<b>STOCKLAND TRUST MANAGEMENT LTD</b> <b>STOCKLAND ROCKHAMPTON</b> <b>PROPOSED EXPANSION</b> <b>PLAN VIEW - SHEET 1 OF 2</b>			
Datum <b>AHD</b>	Date <b>08/06/2017</b>	Scale <b>AS SHOWN</b>	Size <b>A1</b>
Drawing Number <b>R2017033-CI-SK02</b>			Revision <b>C</b>

# Stockland Rockhampton - Restaurant Cinema Precinct

## **STOCKLAND ROCKHAMPTON CENTRE EXPANSION RESPONSE TO ROCKHAMPTON REGIONAL COUNCIL INFORMATION REQUEST**

Figure 1-1 Current and SIDRA Assessed Layout – High Street / Aquatic Place Intersection

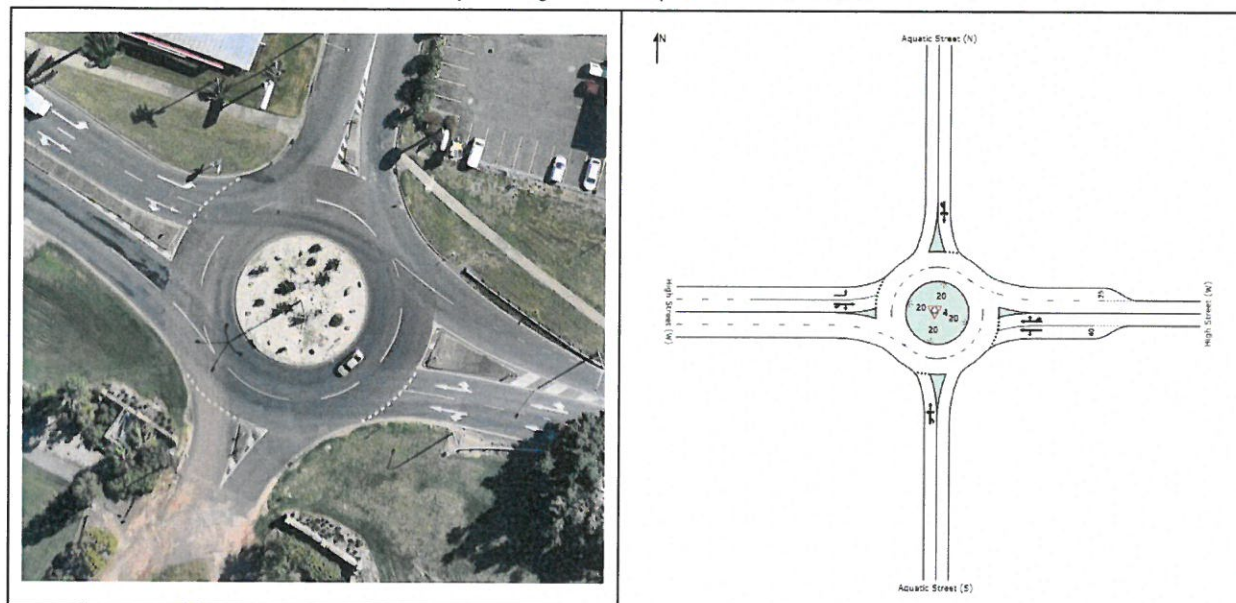
*Please provide a sensitivity analysis to run an alternate distribution of traffic with more share of traffic (40% instead of 30%) within close proximity to the proposed expansion that is through the High Street / Aquatic Place intersection and its impact on High Street / Aquatic Place roundabout and High Street - Alexandra Street / Moores Creek Road intersection.*

In response to item 1, a sensitivity analysis was prepared to test the alternate traffic distribution proposed by Council. The High Street/Aquatic Place and High Street/Alexandra Street/Moores Creek Road intersections were reanalysed in SIDRA and the results are outlined in the following sections.

The current configuration of this intersection is a roundabout arrangement. The aerial and SIDRA assessed layout are illustrated on Figure 1-1.
